SUBJECT: NuScale Power, LLC Response to NRC Request for Additional Information No. 394 (eRAI No. 9407) on the NuScale Design Certification Application

Enclosure 1: NuScale Response to NRC Request for Additional Information eRAI No. 9407

Response to Request for Additional Information Docket No. 52-048

Figure 15.2-7: Reactor Pressure Vessel Pressure - Peak RCS Pressure Case (15.2.1-15.2.3 LOEL-TT-LOCV)

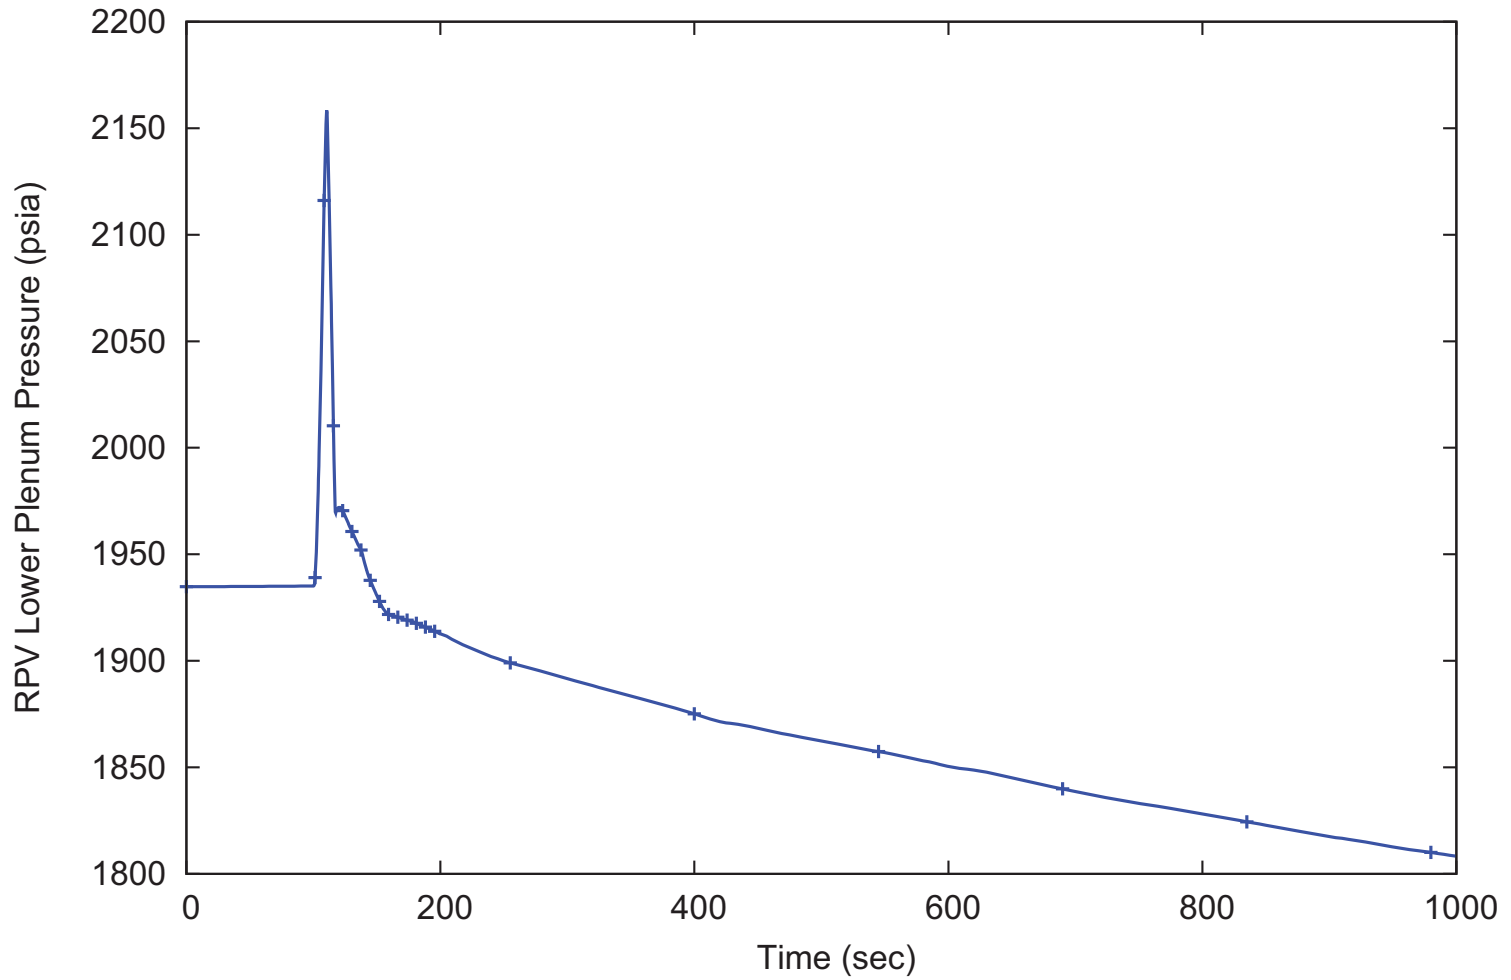
The staff notes that FSAR Figure 15.2-7 shows pressurizer pressure for the LOEL, TT, and LOCV maximum RCS pressure case, but the peak pressure shown in the figure is less than the maximum RCS pressure in FSAR Table 15.2-7 (2158 psia), presumably because the maximum RCS pressure occurs at a different location in the RCS. To allow the staff to verify the RCS pressure response for these events, please provide and add to the FSAR a new figure that shows the pressure response for the location of maximum RCS pressure for the LOEL, TT, and LOCV events.

The requested figure has been added to the FSAR to show reactor pressure vessel (RPV) lower plenum pressure for the limiting loss of external load (LOEL), turbine trip (TT) and loss of condenser vacuum (LOCV) reactor coolant system (RCS) pressure transient scenario.

FSAR Figure 15.2-7 has been revised as described in the response above and as shown in the markup provided in this response.

Figure 15.2-12: Net Reactivity - Peak RCS Pressure Case (15.2.4 MSIV Closure)

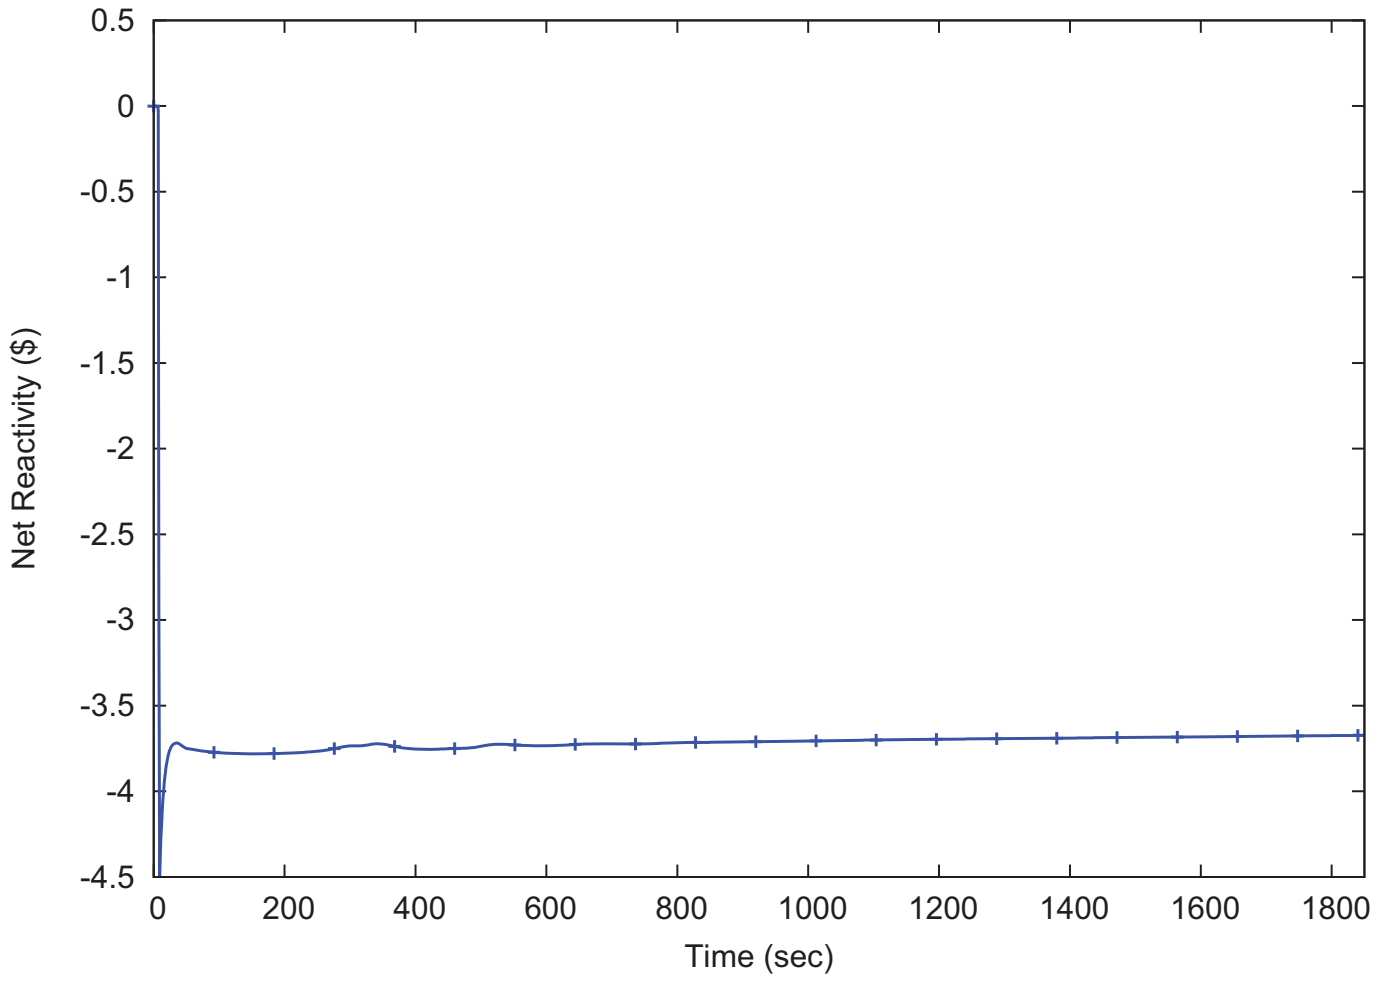
- FSAR Section 15.2.1.3.3, “Results,” refers to limiting MCHFR in Figure 5.2-9, but the correct figure number is 15.2-9.
- FSAR Sections 15.2.2.2 and 15.2.3.2, both titled “Sequence of Events and System Operation,” refer to more than one turbine stop valve (TSV). However, the staff notes that FSAR Chapter 10 indicates there is only one TSV per NPM.
- The title of Table 15.2-3 indicates it is a sequence of events table, but it is actually an initial conditions table.
- FSAR Tier 2, Figure 15.2-12 is titled “Net Reactivity – Peak RCS Pressure Case (15.2.4 MSIV Closure)” but appears to show RCS flow rate instead.

The FSAR Sections, Table and Figure noted above have been corrected. In addition, an editorial correction is made to the caption of Table 15.2-2.

FSAR Sections 15.2.1.3.3, 15.2.2.2, 15.2.3.2, Tables 15.2-2, 15.2-3 and Figure 15.2-12 have been revised as described in the response above and as shown in the markup provided in this response.
